Access Compliance Report

Public Rights-of-Way

Intersection ID: 21442	Main Street: E_ARROWOOD_RD	Cross Street: GRAND_METIS_DR	Location: NW
ADA ID: 99C75C337048	Ramp Type: PerpDiag	Initial Pass/Fail: Fail	Overall Compliance: No
Severity Score: 67.5			
Codes/Mitigation Info/Possible Solution		Field Measurements/Component Compliance

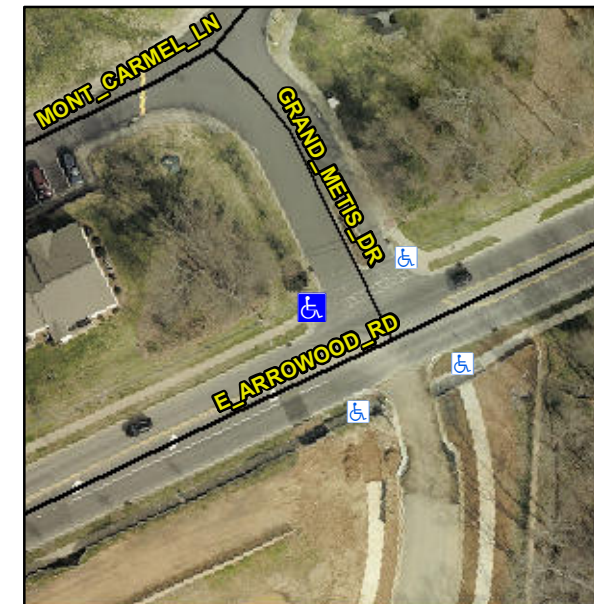
R304.5.1, R304.2.2, R304.5.3

Compliance	Description	Data	Compliance	Description	Data
N/A	Ramp Length (in)	61.0	No	Ramp Slope (%)	12.3
No	Ramp Width (in)	35.0	No	Ramp XSlope (%)	9.1
N/A	Flare Type LT	N/A	N/A	Flare Type RT	N/A
N/A	Flare Slope LT (%)	N/A	N/A	Flare Slope RT (%)	N/A
N/A	Flare Traversable LT?	N/A	N/A	Flare Traversable RT?	N/A
N/A	Landing Length (in)	N/A	N/A	DWS Provided?	N/A
N/A	Landing Width (in)	N/A	N/A	DWS Contrast?	N/A
N/A	Landing Slope (%)	N/A	N/A	DWS Length (in)	N/A
N/A	Landing X Slope (%)	N/A	N/A	DWS Full Width?	N/A
N/A	Landing Curb? (Y/N)	N/A	N/A	DWS Offset (in)	N/A
N/A	Shared Landing?	N/A			
N/A	Gutter Ponding?	N/A	N/A	Gutter Slope (%)	N/A
N/A	Gutter Lip Ht (in)	N/A	N/A	Gutter X Slope (%)	N/A
N/A	Painted X Walk1?	No	N/A	Painted X Walk2?	Yes
	X Walk 1 Direction	To S		X Walk 2 Direction	To NE
N/A	X Walk 1 Width (in)	N/A	N/A	X Walk 2 Width (in)	53.0
	X Walk 1 Slope (%)	2.1		X Walk 2 Slope (%)	7.8
	X Walk 1 X Slope (%)	5.7		X Walk 2 X Slope (%)	0.2

N/A	Ramp inside XWalk1?	N/A	N/A	Ramp inside XWalk2?	Yes
	Road Slope (%)	6.0	N/A	Clear Space?	N/A
	Road X Slope (%)	4.2	N/A	Clear Space to XWalk (in)	N/A
N/A	Any Obstructions?	N/A	N/A	Storm Grate/Utility Hazard?	N/A
	Obstruction Type			Storm Grate/Utility Type	
		N/A			N/A
		Yes		Surface Condition? (G/P)	Good

Remove & Replace Curb Ramp With Two New Directional Ramps or Equivalent.
